**REBUTTAL TESTIMONY OF**

**JAMES W. NEELY, P.E.**

**DOMINION ENERGY SOUTH CAROLINA, INC.**

**DOCKET NO. 2019-226-E**

**Graph A: Gas Price Predictions**

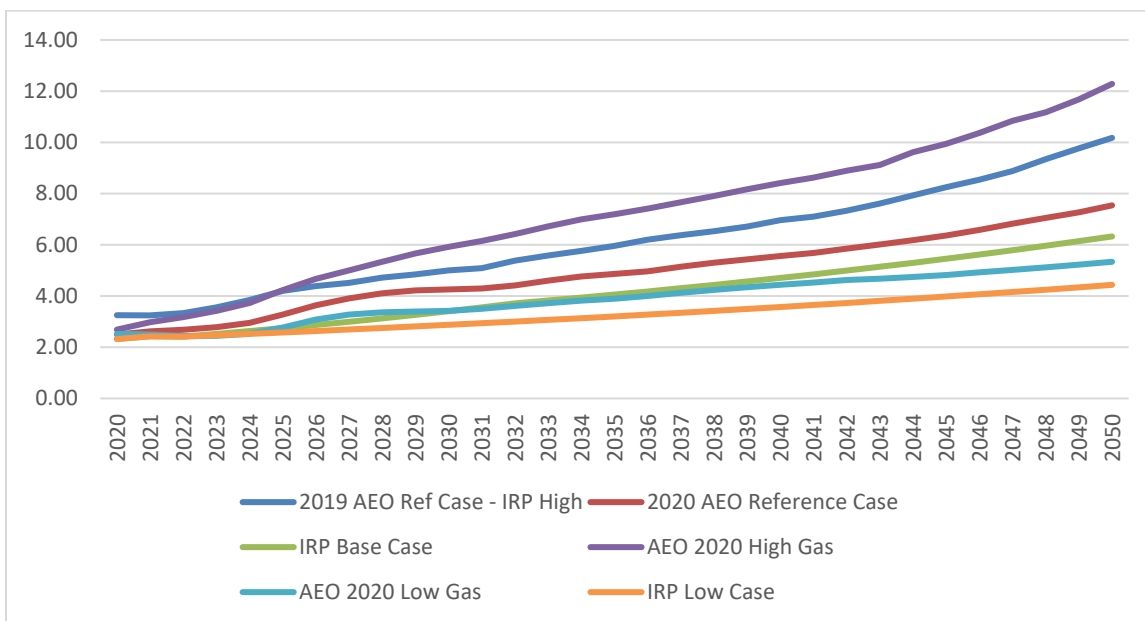
10 **Q. HOW DO YOU RESPOND TO MR. SERCY'S RECOMMENDATION**  
11 **THAT THE COMPANY UNDERSTATED NATURAL GAS PRICES**  
12 **BY USING PRICES THAT ARE IN "STARK CONTRAST" TO**  
13 **THOSE CONTAINED IN THE ENERGY INFORMATION**  
14 **ADMINISTRATION'S ANNUAL ENERGY OUTLOOK ("AEO")**  
15 **REPORT (PP. 26-28)?**

16 A. Mr. Sercy testifies in support of using the 2019 AEO gas prices  
17 forecasts and criticizes DESC for relying on gas price predictions that were  
18 substantially lower than those of the 2019 AEO report. The AEO 2020 report  
19 is now available and shows a lower price forecast. The AEO reference case  
20 has moved lower and is now located between the IRP Base Case and IRP  
21 High Gas Case and closer to the IRP Base Case than the IRP High Gas case.

As Company witness Mr. Bell testifies, the Company is planning to review its gas cost assumptions in future IRP updates. But the current range of gas price sensitivities is not unreasonable. The AEO 2020 reference case is shown in the graph below, along with IRP gas price forecasts.
